## STAFF REPORT ADDENDUM

APPLICATION RZ 2012-DR-017

**PROPOSAL:** To rezone from the R-2 District to the R-3 District to permit two single family detached dwellings at a density of 2.15 du/ac.

# MID PIKE SUBDIVISION LOT 82 BLOCK 1 DRANESVILLE DISTRICT #1 FAIRFAX COUNTY, VIRGINIA GENERALIZED DEVELOPMENT PLAN REZONING & SUBDIVIDING RZ 2012-0147 7250 IDYLWOOD ROAD FALLS CHURCH, VA 22043

824  
CO-2  
SHEET 2 OF 7

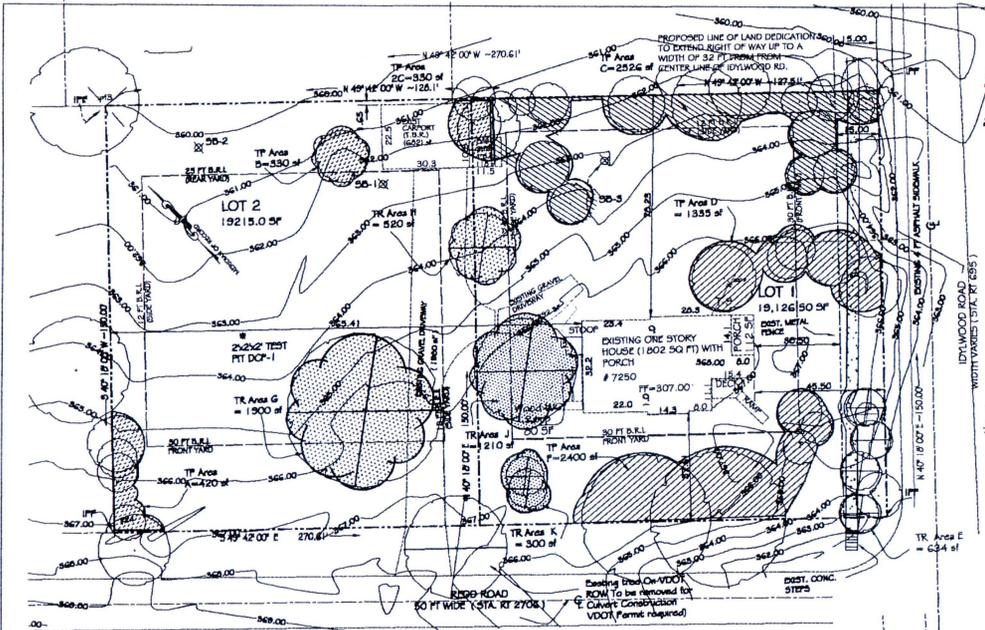
- Lot Sizes, Lot Widths, and Setbacks** (Sheet 2 of GDP): This alternative GDP shifts the lot line that divides the lots to the west to accommodate two individual driveways. As a result, the proposed lot sizes, lot widths, and side yard setbacks to the common property line will differ between the two alternatives. Both lots would continue to meet the lot size, lot width, and setback requirements. The chart below summarizes the differences in lot size, lot width, and side yard setbacks between the two development options.

824  
GDP-1  
SHEET 3 OF 7

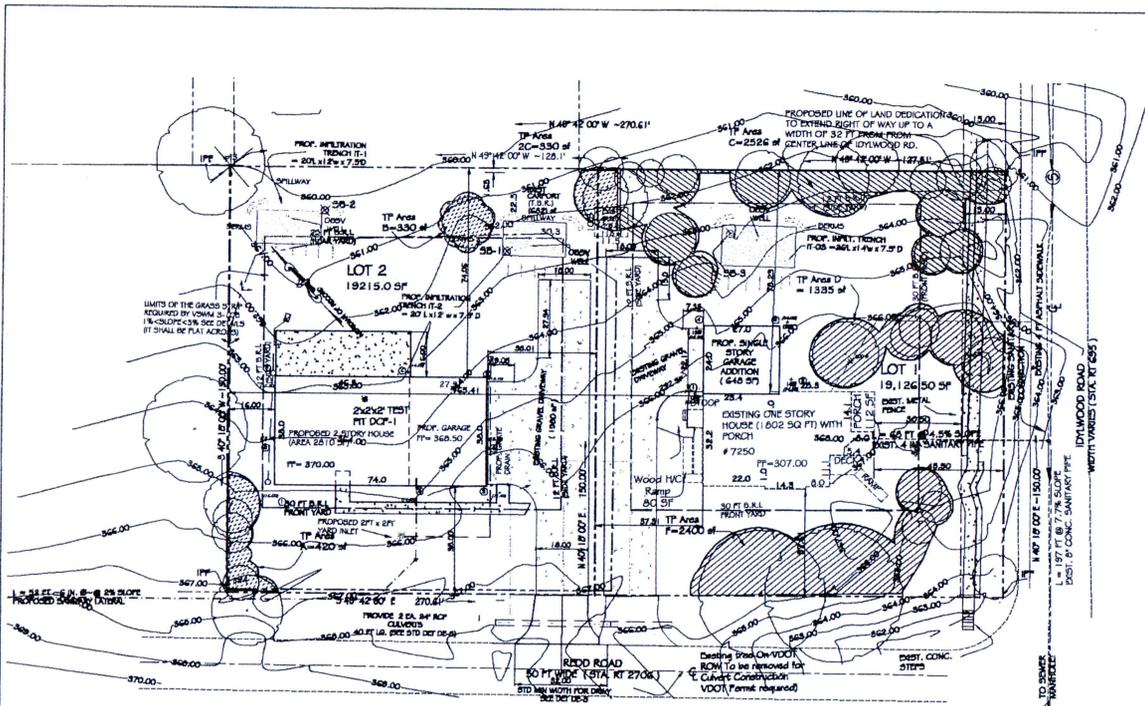
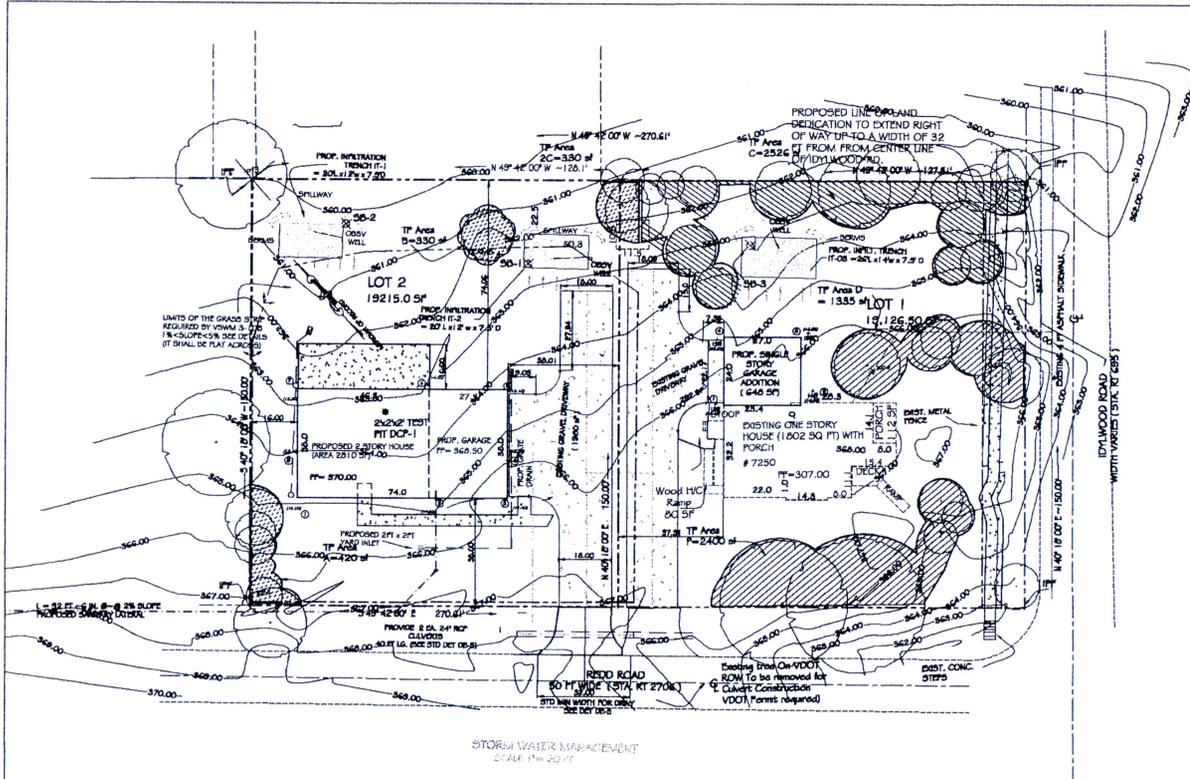
- **Stormwater** (Sheets 3, 4, and 5 of the GDP): The individual driveway option will increase the impervious area in comparison to the shared driveway option; this will impact the stormwater management calculations. As stated the proffers, the applicant will be required to meet the stormwater management and BMP requirements as determined by DPWES prior to Subdivision Plan approval. This commitment would apply to both development alternatives.

- **Proffer #6:** The applicant added a sentence that states that prior to subdivision plan approval, stormwater management (SWM), best management practices (BMP) facilities, and adequate outfall shall be provided in accordance with the PFM as determined by DPWES. This would be applicable for both development scenarios.

824 GDP-4 SHEET 6 of 7

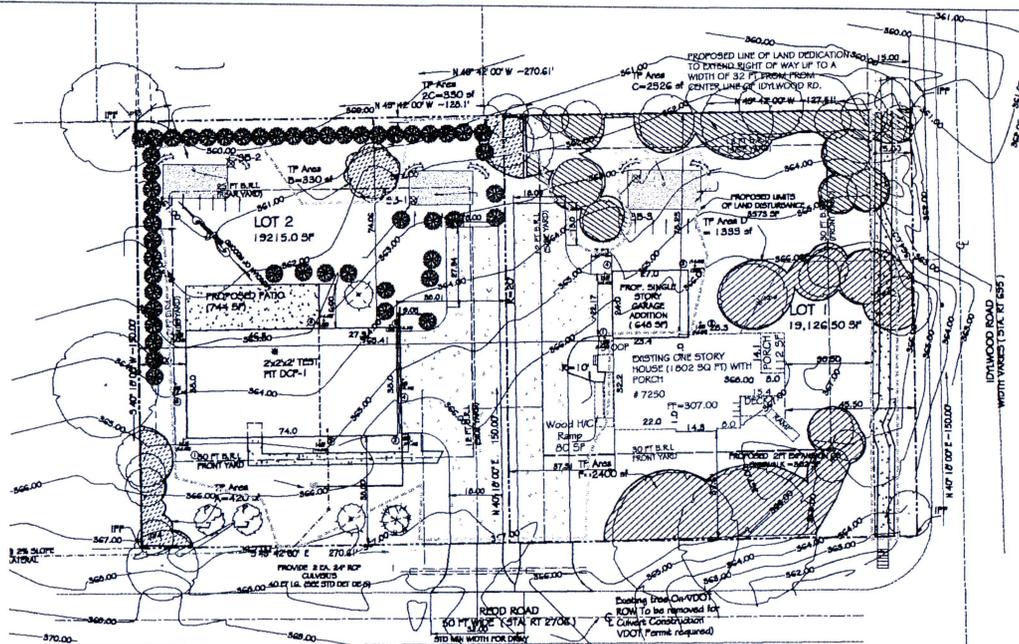
- Tree Preservation** (Sheets 6 and 7 of the GDP): Several additional trees would be removed to accommodate the individual driveways in comparison to the shared driveway alternative: two small trees (5 – 6 inch caliper) located near the Redd Road frontage on lot 1 and one large white oak tree (44 inch caliper) located to the west of the existing dwelling on proposed lot 1. Although the applicant's tree preservation calculations shown on sheet 7 the GDP have not been revised to reflect the removal of these trees, supplemental calculations have been provided (Attachment 2)

that indicate that the applicant intends to continue to meet the tree preservation target and tree canopy requirements after the removal of these additional trees. The applicant's revised proffers commit to meeting the tree preservation and tree canopy requirements with the proposed development. This commitment would apply to both the shared driveway and the individual driveway development alternatives.

- **Proffer #13a:** The applicant added a new proffer 13a that states that the applicant shall satisfy the tree preservation and tree canopy requirements of the PFM.
